HISTORIC LANDMARK COMMISSION OCTOBER 28, 2013 NATIONAL REGISTER HISTORIC DISTRICT NRD-2013-0075 Old West Austin 2211 Windsor Road East

Revise façade features and construction a rear addition to a contributing house.

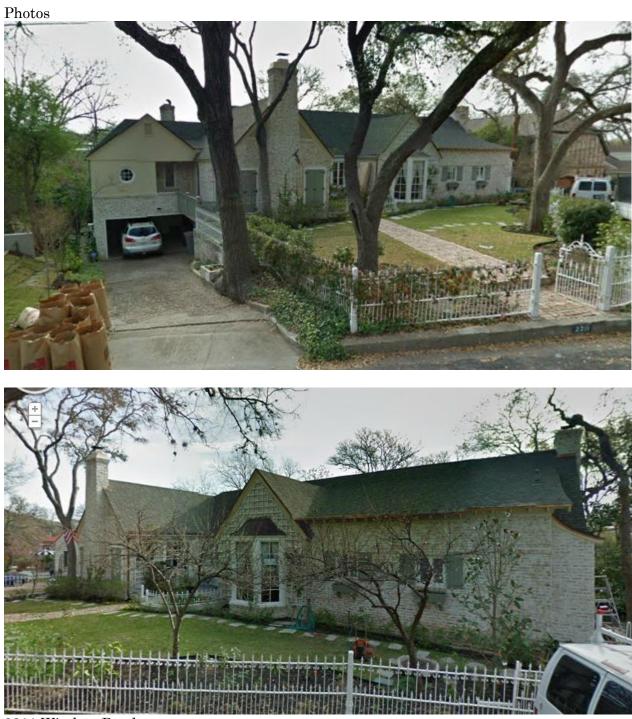
Since the proposed changes to the façade eliminate many of the original character defining features that give the house its Tudor Revival style they do not meet the guidelines and will render the property no longer contributing to the National Register District.

Release the permit per the proposed design with the recommendation that the applicant consider retaining the original façade features to maintain contributing status, and require a City of Austin documentation package be submitted prior to release of the permit.
